## Amendments to the Drawings:

Application No. 10/625,576 Amendment Dated April 7, 2004 Reply to Office Action of March 23, 2004 Annotated Sheet Showing Changes

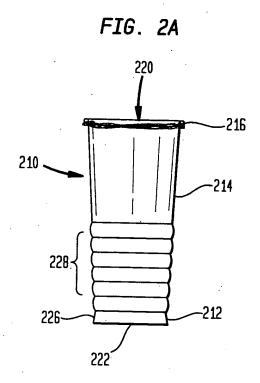
On Figure 1A, it is proposed to show inner diameter 32 more accurately as well as height 35 and width 31 of the rim. These proposed changes conform the drawing better to the text at p. 21, lines 4-26:

See case As FILED; P. 21 Fig. 4 ALSO

Tumbler 10 is optionally provided with a molded-in design 28 which is more clearly seen by reference to Figures 1(b) and 1(c). Base sidewall 26 extends upwardly to define an outer edge 30 which attaches to sidewall 14. Sidewall 14 extends upwardly to fortified rim 16. Rim 16 is integrally formed with sidewall 14 and is a continuous generally circular or oval, solid polymer bead extending about periphery 18 of opening 20. Rim 16 has a width 31 which is defined by the difference between an inner diameter 32 and an outer diameter 34 of rim 16 and a height 35 which is the distance over which width 31 extends. Width 31 is thicker than adjacent sidewall portion 38 which is typically of the same caliper as the reset of sidewall 14. In the example shown in Figures 1(a) – 1(c), adjacent sidewall portion 38 has a thickness of 10 mils, height 35 is approximately 28 mils and width 31 is approximately 40 mils at its thickest point.

Other dimensions of tumbler 10 are indicated on Figure 1A. Base portion 12 has a diameter D, at edge 30 of about 2.125 inches, an outer upper diameter 34 of 2.770 inches an inner upper diameter 32 of 2.730 inches. The overall height, H, of tumbler 10 is 5.785 inches. These dimensions define an angle of taper T as shown about imaginary central axis 40 of about 3° for sidewall 14 of tumbler 10. As used herein "taper", "degree of taper" and like terminology indicates the angle that the sidewall of the inventive tumbler makes with the imaginary central longitudinal axis defined by the sidewall which is substantially perpendicular to bottom 22, the taper of the article may also be thought of as the angle the sidewall makes with the bottom less 90 degrees.

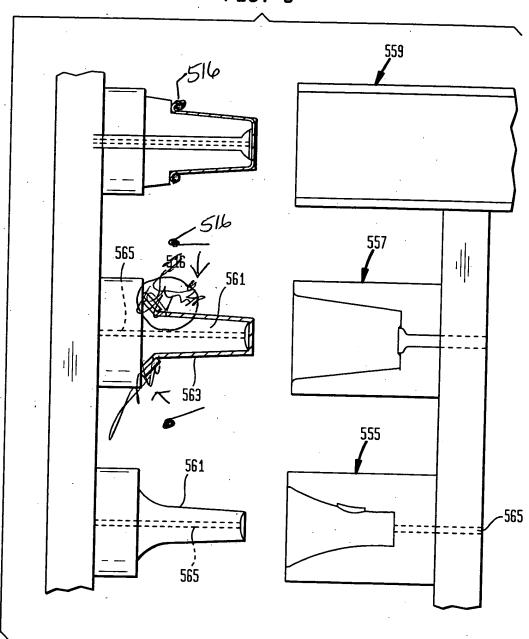
On Figure 3A, thickness 331 and height 335 of the rim should be shown as on Figure 1. Also, the rim should be shown as in Figures 1 and 2. These changes are supported by the specification as filed at p. 23, lines 8-20:

SEE P. 23 F16-4

Base sidewall 326 extends upwardly to define an outer edge 330 which attaches to sidewall 314. Sidewall 314 extends upwardly to fortified rim 316. Rim 316 is integrally formed with sidewall 314 and is a continuous generally circular or oval, solid polymer bead extending about periphery 318 of opening 320. Rim 316 has a width 331 which is defined by the difference between an inner diameter 332 and an outer diameter 334 of rim 316 and a height 335 which is the longitudinal distance over which width 331 extends. Width 331 is thicker than adjacent sidewall portion 338 which is typically of the same caliper as the rest of sidewall 314. In the example shown, adjacent sidewall portion 338 has a thickness of 20 mils height 335 is approximately 28 mils and width 331 is approximately 40 mils at its thickest point. Other dimensions of tumbler 310 are approximately identical to those of tumblers 210 of Figures 2(a) and 2(b) and tumbler 10 of Figures 1(a) – 1(c). Tumbler 310 thus has a taper of 3°.

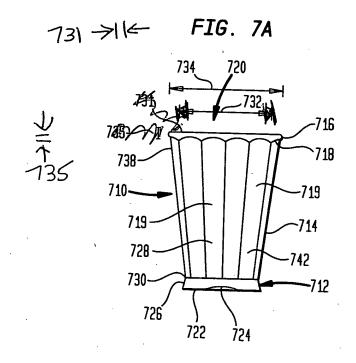
Figure 7A should be conformed to Figures 1A, 2A, 3A and 6A. These changes conform the Figure to the text at the bottom of page 27 and top of page 28:

SEE p.27-28

Rim 716 is integrally formed with sidewall 714 and is a continuous generally circular or oval, solid polymer bead extending about periphery 718 of opening 720. Rim 716 has a width 731 which is defined by the difference between an inner diameter 732 and an outer diameter 734 of rim 716 and a height 735 which is the distance over which width 731 extends. Width 731 is thicker than adjacent sidewall portion 738 which is typically of the same caliper as the rest of sidewall 714. In the example shown, adjacent sidewall portion 738 has a thickness of 20 mils, height 736 is approximately 28 mils and width 731 is approximately 40 mils at its thickest point.

Other dimensions of tumbler 710 are generally as indicated in connection with tumbler 610 of Figure 6. Sidewall 714 of tumbler 710 has a taper of approximately 6.5 degrees.

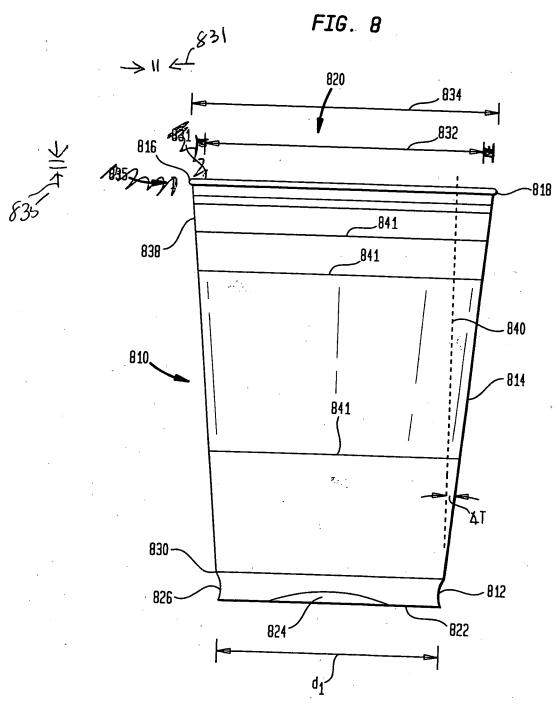
Figure 8 should be consistent with the other tumblers and text at page 29, beginning on line 10:

SEE P.29

Base sidewall 826 extends upwardly to define an outer edge 830 which attaches to sidewall 814. Sidewall 814 extends upwardly to fortified rim 816. Rim 816 is integrally formed with sidewall 814 and is a continuous generally circular or oval, solid polymer bead extending about periphery 818 of opening 820. Rim 816 has a width 831 which is defined by the difference between an inner diameter 832 and an outer diameter 834 of rim 816 and a height 835 which is the distance over which width 831 extends. Width 831 is thicker than adjacent sidewall portion 838 which is typically of the same caliper as the rest of sidewall 814, that is, sidewall 814 is substantially uniform in thickness on the entire tumbler. In the example shown, adjacent sidewall portion 838 has a thickness of 20 mils, height 835 is approximately 28 mils and width 831 of rim 816 is approximately 28 mils and width 831 of rim 816 is approximately 40 mils at its thickest point. The tumbler is also provided with a series of molded-in grooves 841 which extend around the tumbler. These grooves

provide a grip for a user as well as providing rigidity to the article. Typically, the circumferential grooves **841** have a depth of from **810** to 40 mils.

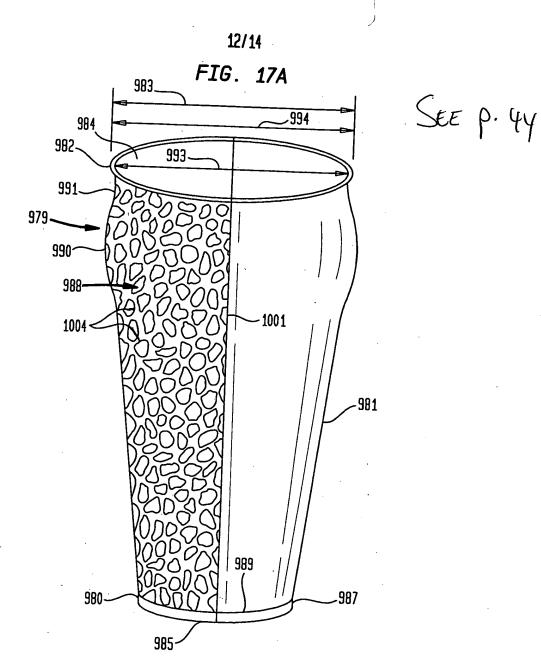
Finally, on **Figure 17A**, lines **1004** should extend to the edge of the embossed area as noted on p. 44, lines 5-7:

For example, tumbler 979 can optionally be provided with an embossing design defined by embossed flat surfaces 988 and ridges 1004 which circumscribe the embossed areas 988.
